1963 - 1964 Corvette: Service News: Air Conditioning Changes

Subject: Air Conditioning Changes

Model and Year: 1963 - 1964 Corvette

Source: Chevrolet Service News

Fig. 1—Rework of Blower Motor Circuit

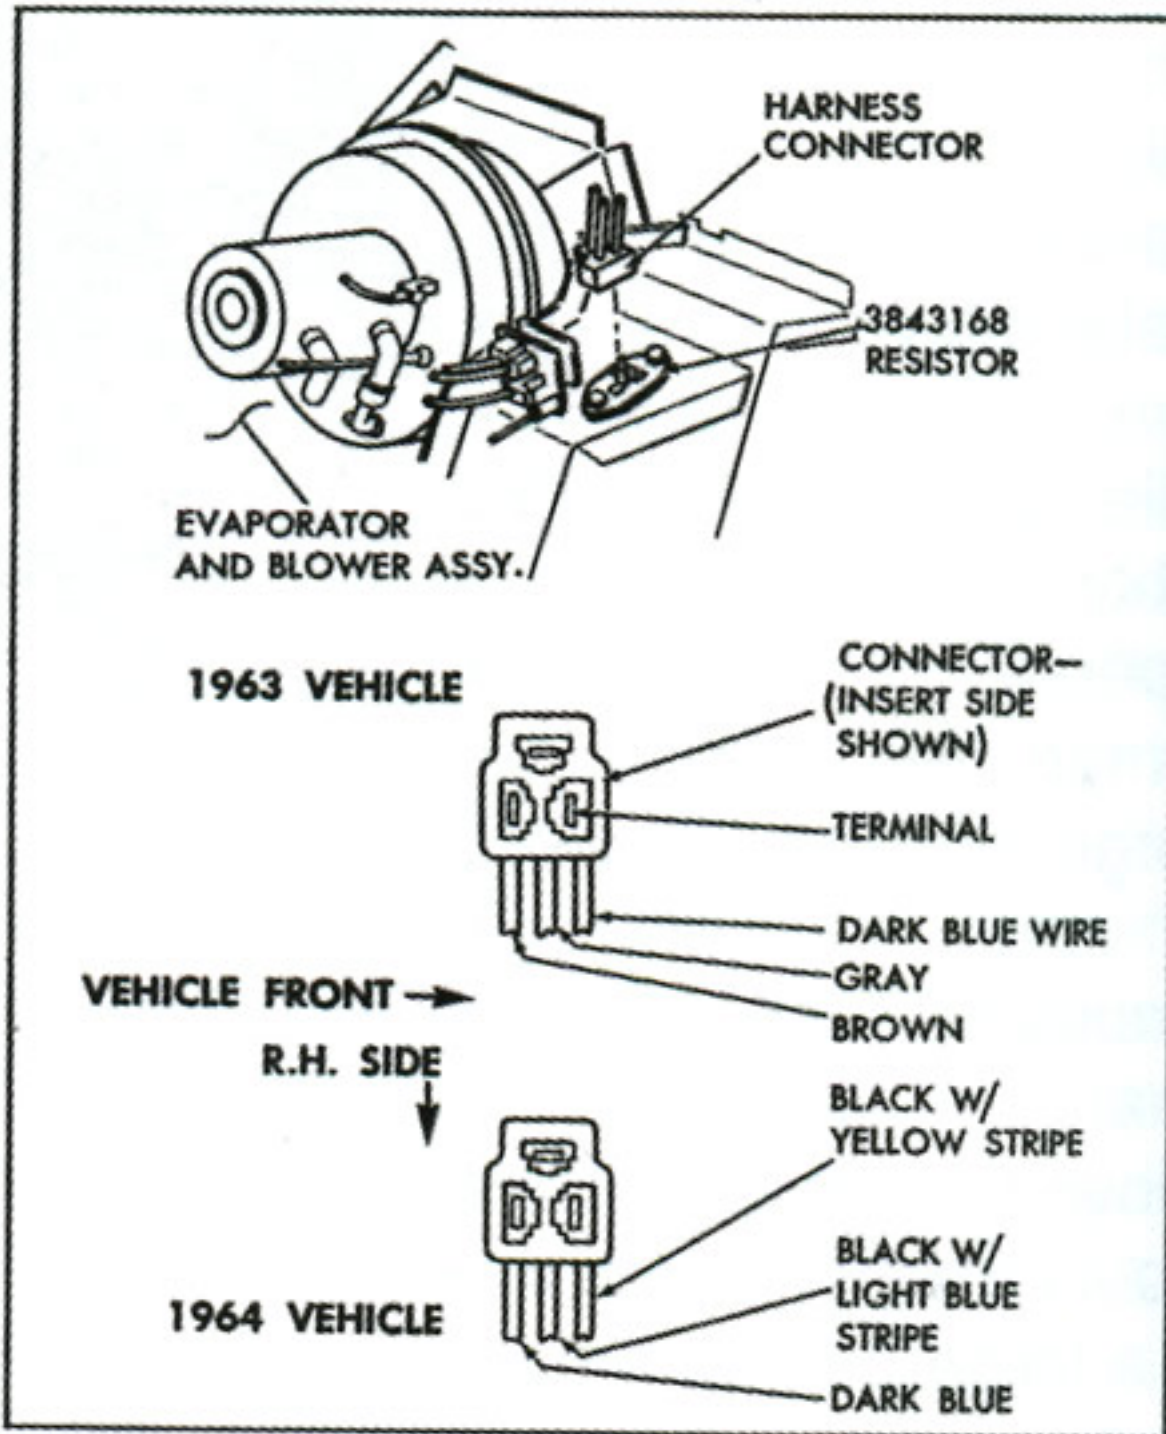
On all 1963 and early 1964 Corvettes equipped with Air Conditioner RPO C60, it would be necessary to slightly modify the electrical circuit to provide a true medium blower speed for the heater. In these RPO C60 installations, the resistor that was used in the blower motor circuit to establish blower medium and low speeds, unfortunately, during heater operation provides blower "low" RPM at the MEDIUM as well as at the LOW speed setting of the operator's control lever.

A wiring change introduced in Production averted the above problem on vehicles built later than December 16, 1963.

To provide the desired medium blower speed, on the earlier production units, proceed as follows:

1. Replace the installed blower motor resistor with Resistor Part No. 3843168.
2. Reverse the location of two leads in the multiple connector that plugs into the blower motor resistor assembly; reinstalling the color coded leads in the connector body at the locations show in Fig. 1.

NOTE: To remove the terminals from the connector body, insert a small screwdriver along the inboard side of the terminal and move the end of the screwdriver outboard to disengage the terminal from the locking ledge in the connector. Before reinstalling the terminals in the connector, spread the

terminals to insure that they lock securely when installed.
